## PLANNING COMMISSION MEETING

**RE: Ginko Self Storage -Final Site Plan/Final Engineering Plan Review-3<sup>rd</sup> Review  
Stormwater Maintenance Agreement Review-1<sup>st</sup> Review**

## Revised Final Site Plan Review for Special Land Use for White Lake Charter Township, Michigan

# GINKO SELF STORAGE

DRAWING TITLE  
**FLOOR PLAN AND BUILDING ELEVATIONS**

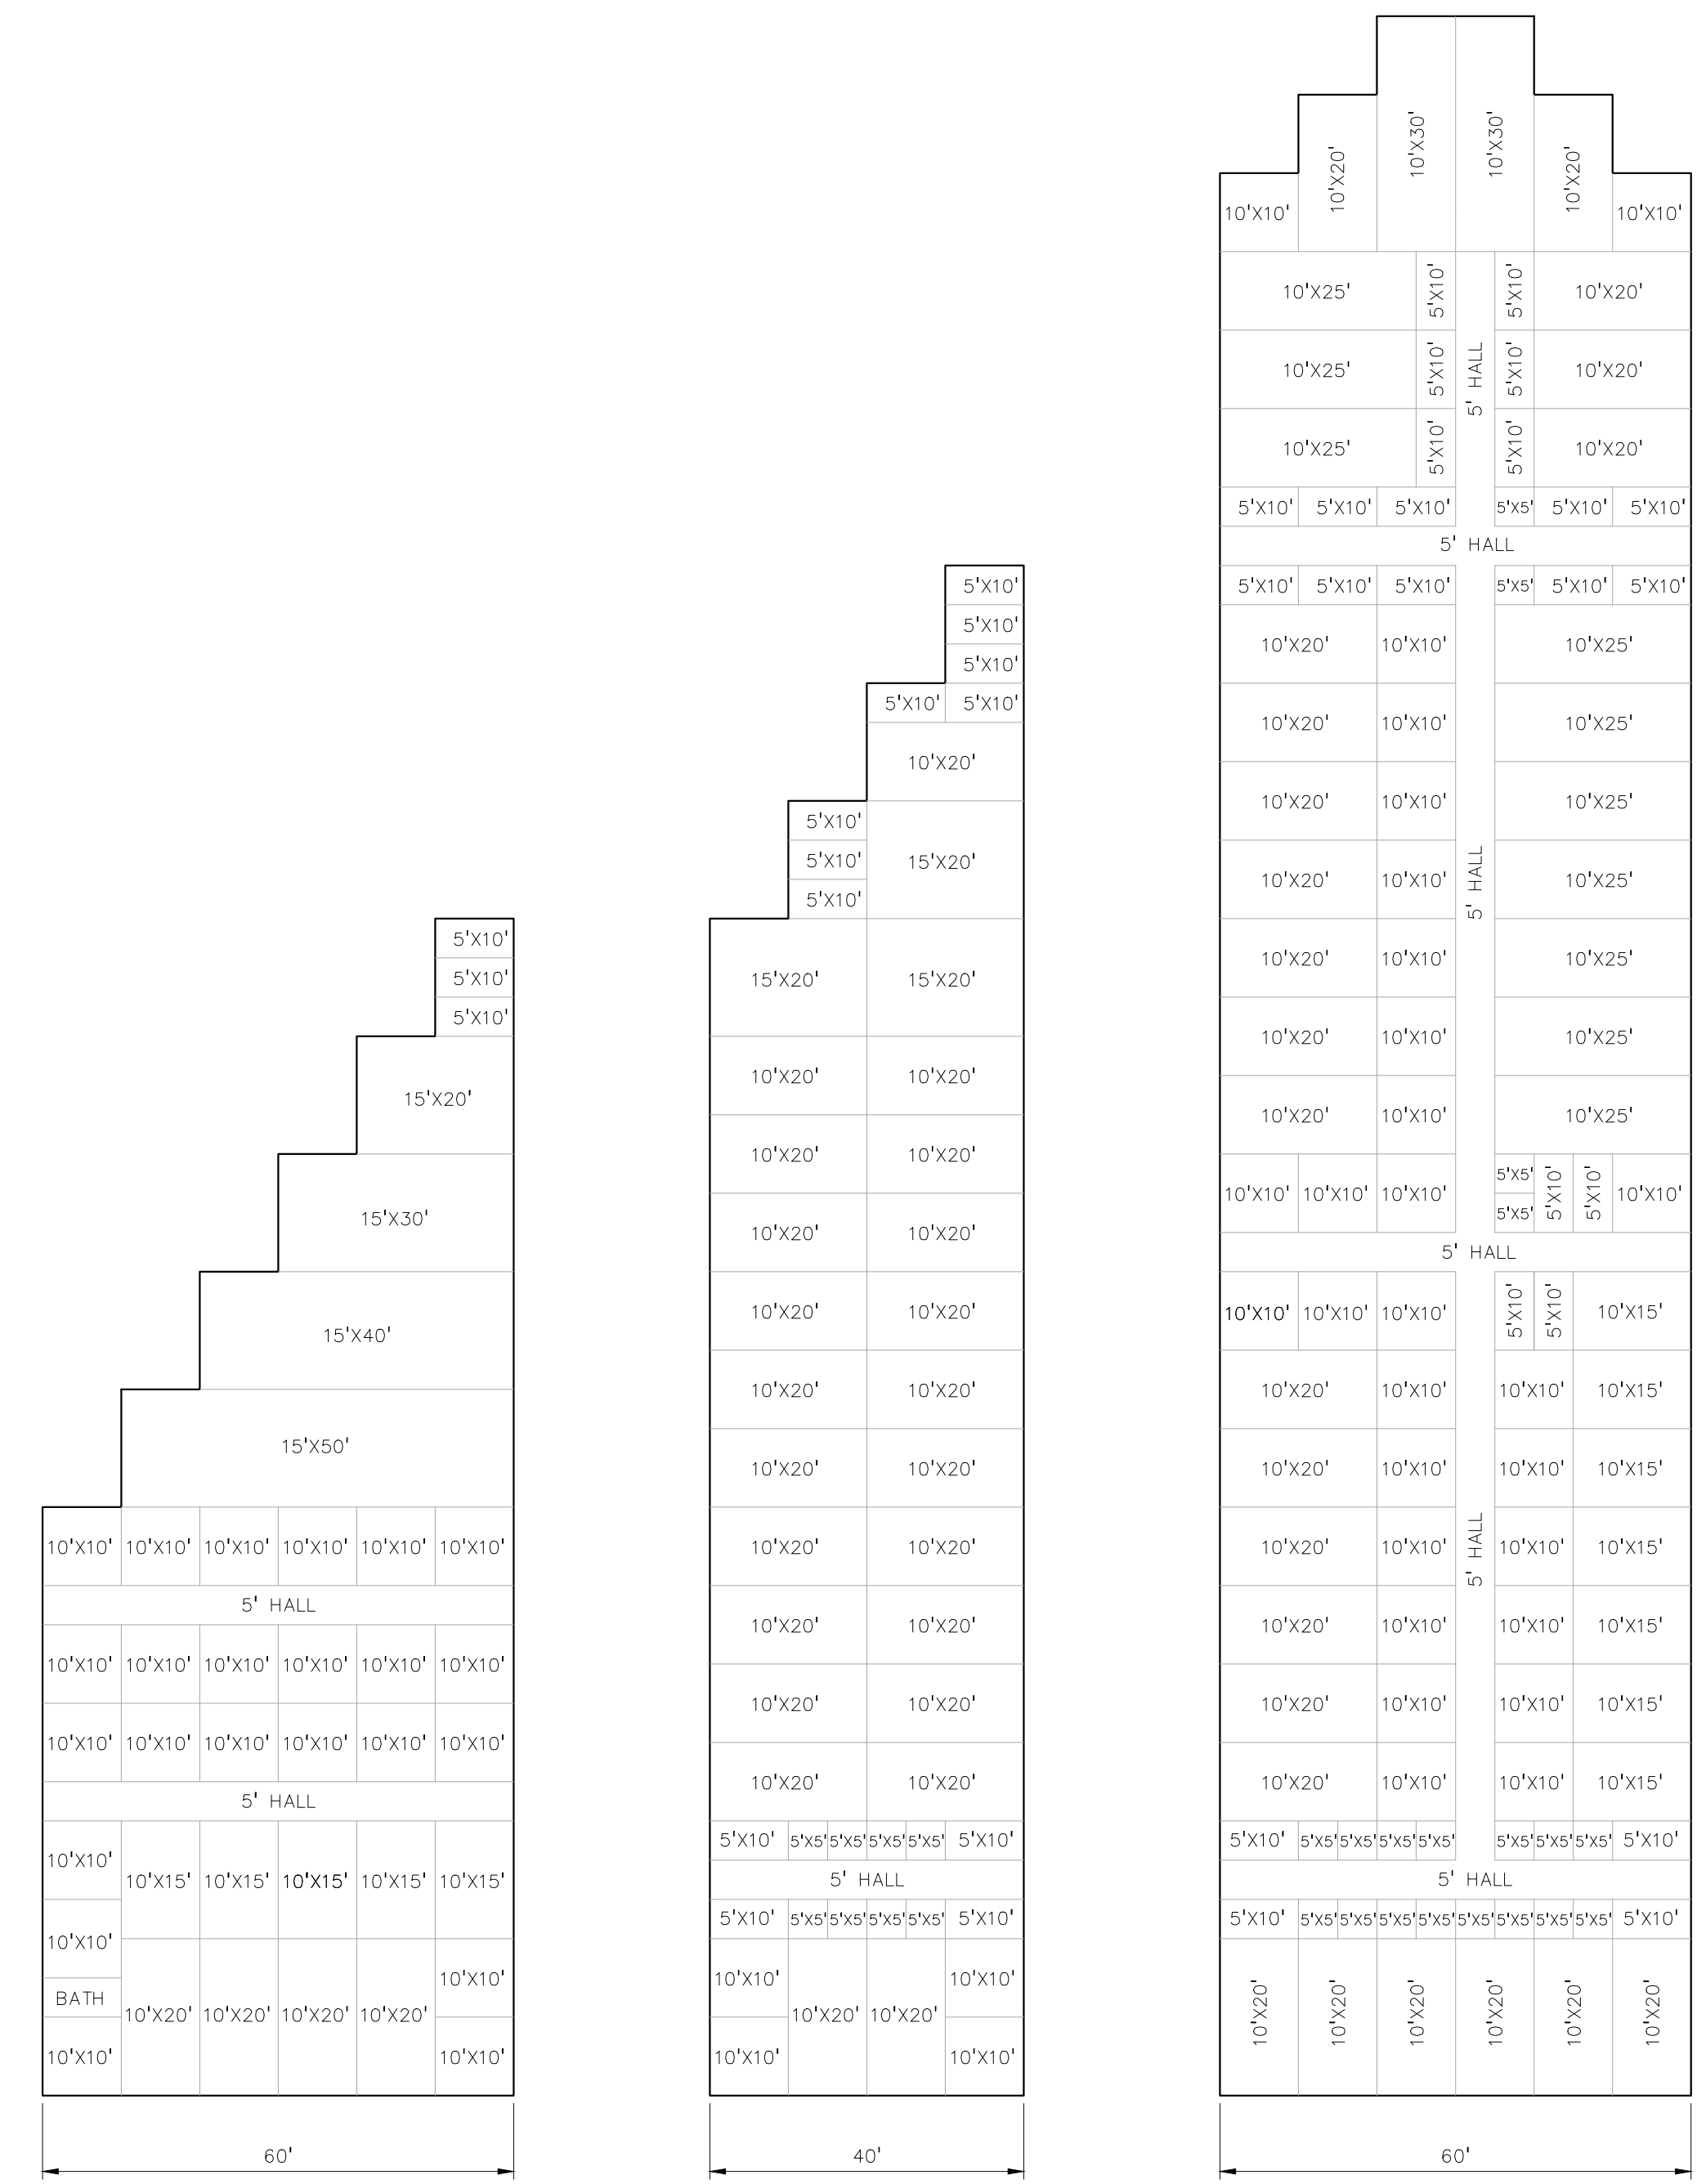
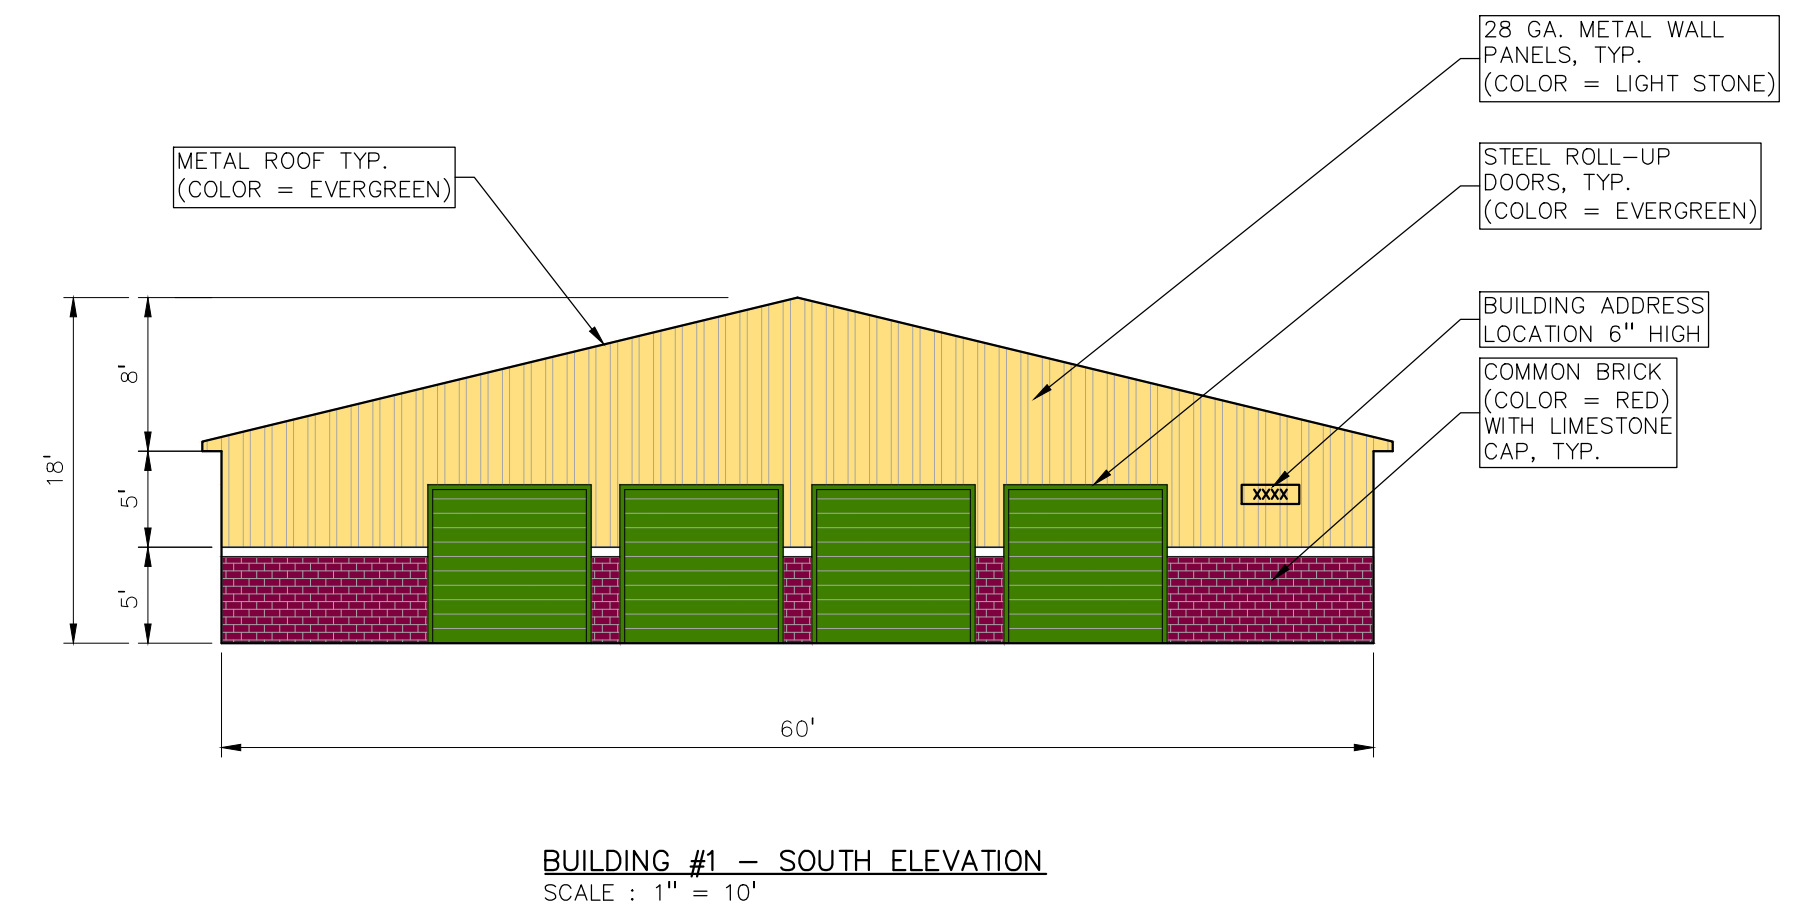
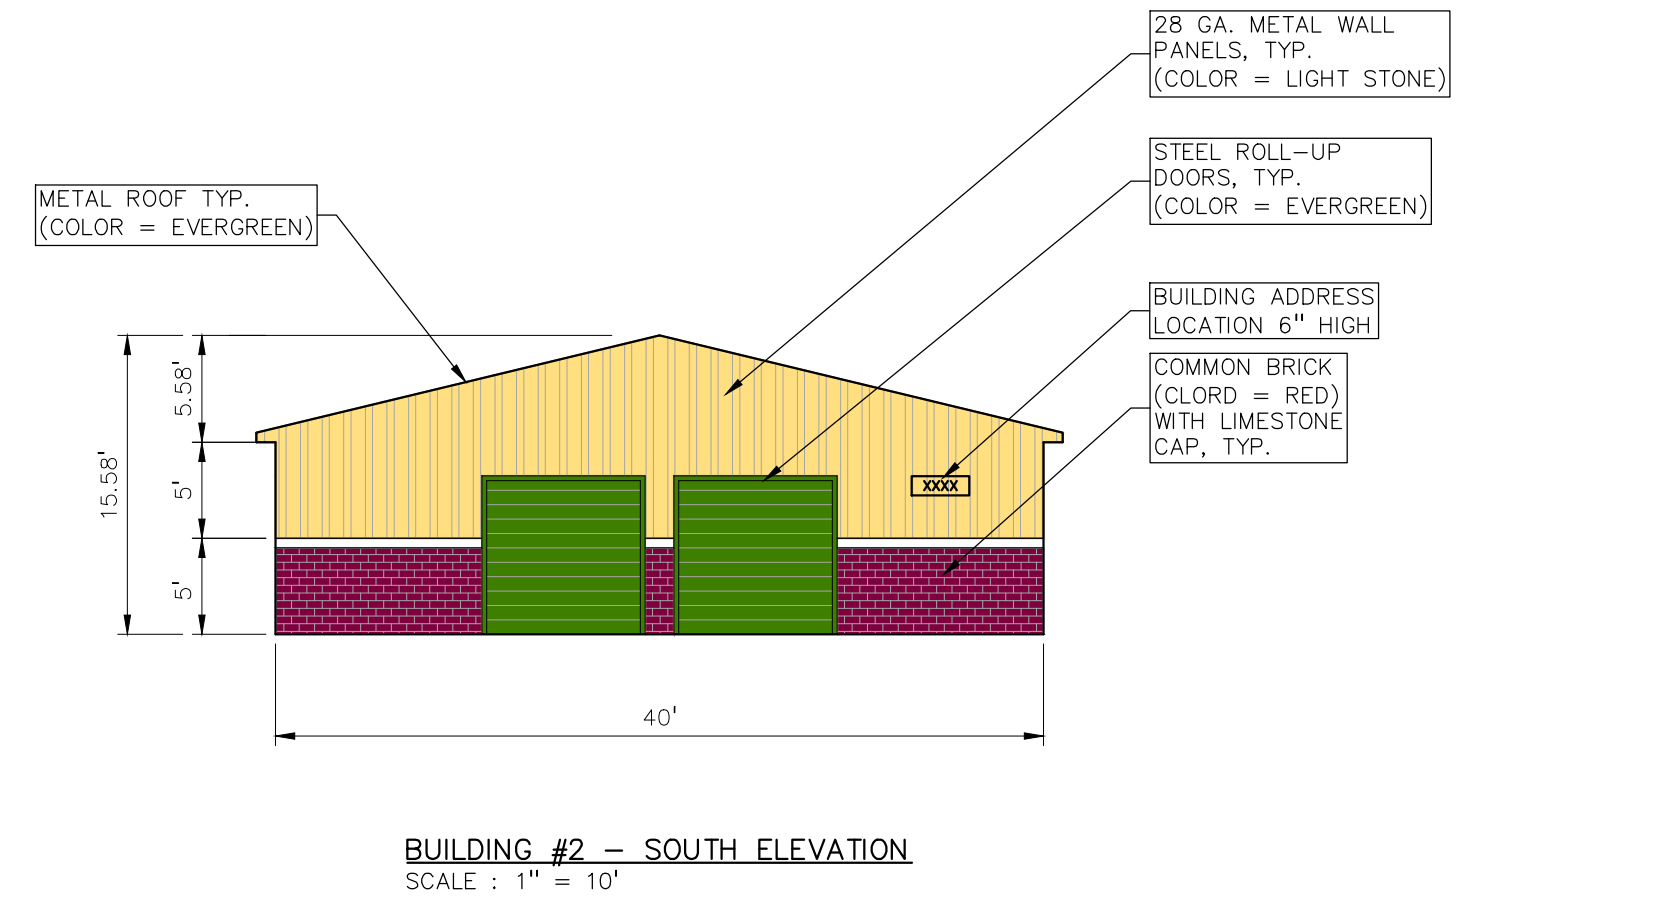
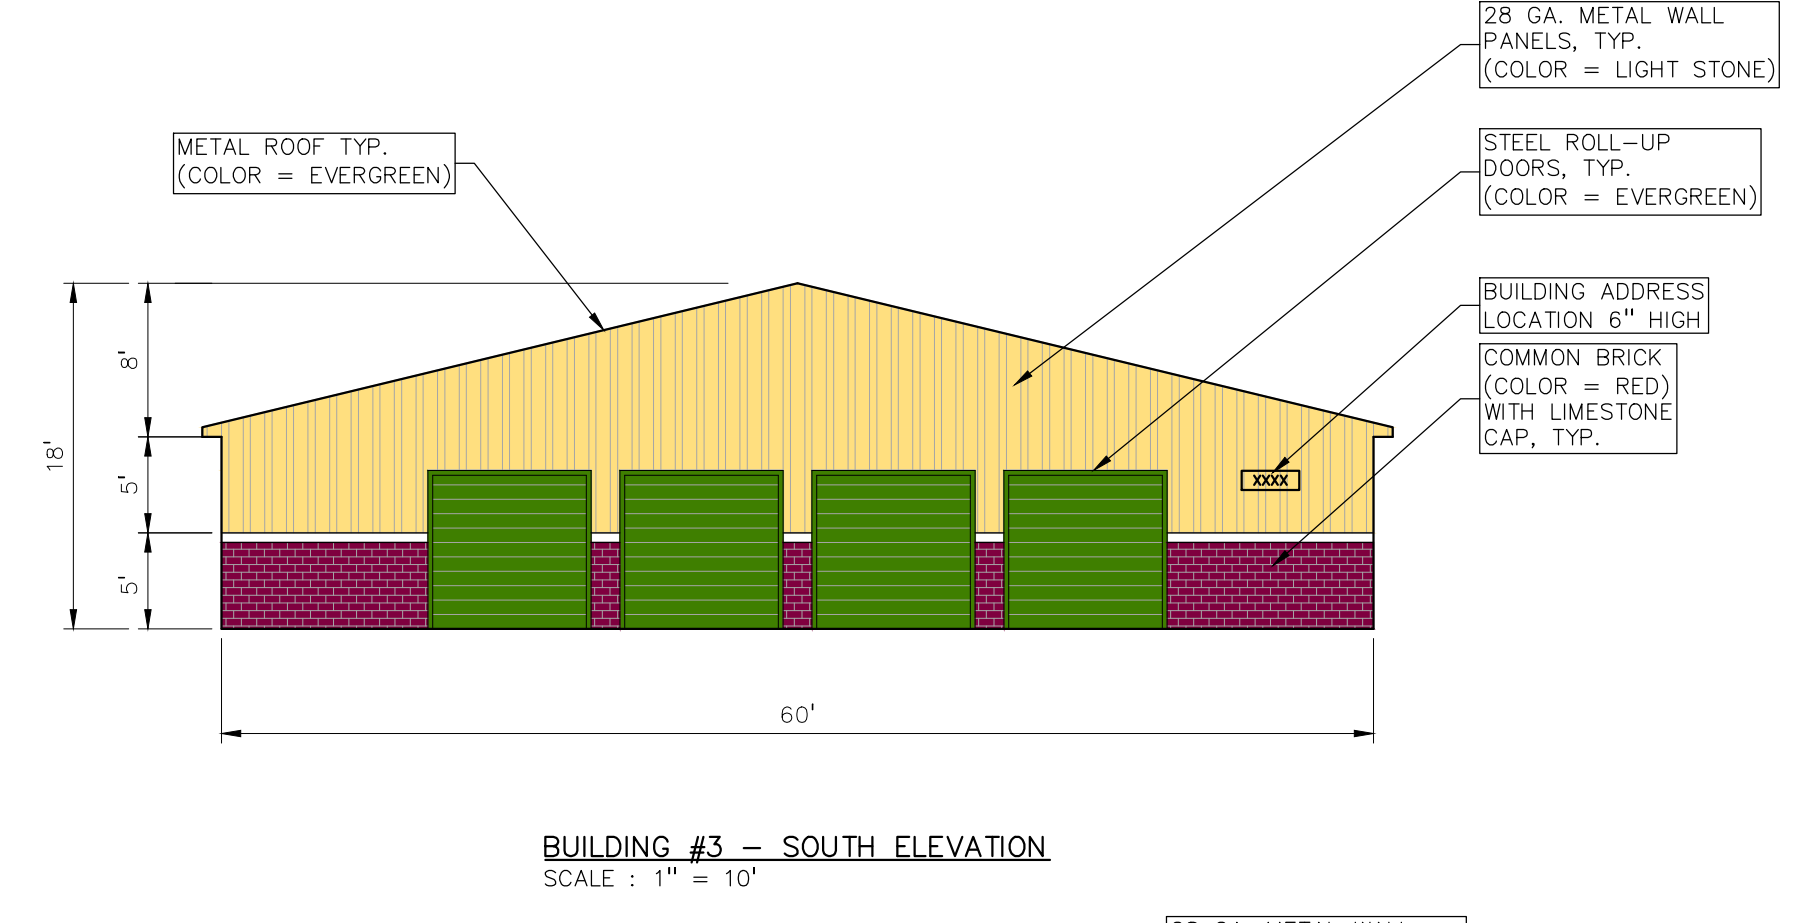
Architectural information required at final site plan review includes the types of facing materials to be used on structures. Sheet A-1.0 indicates all elevations will be faced with metal panels, steel roll up doors, and common brick with limestone caps. The sheet provides a note stating *“A material sample board shall be provided for the Planning Commission review. Colored elevations shall be provided as part of the final site plan review”*. Colored elevations are included in the final stie plan.

**Items to be Addressed:** *1.) Exterior construction material sample boards and colored elevations shall be provided for Building Official and Planning Commission review. Comment remains as a notation. 2.) Roofing materials and colors should be shown on color elevations as well as Sheet A-1.0. Addressed.*
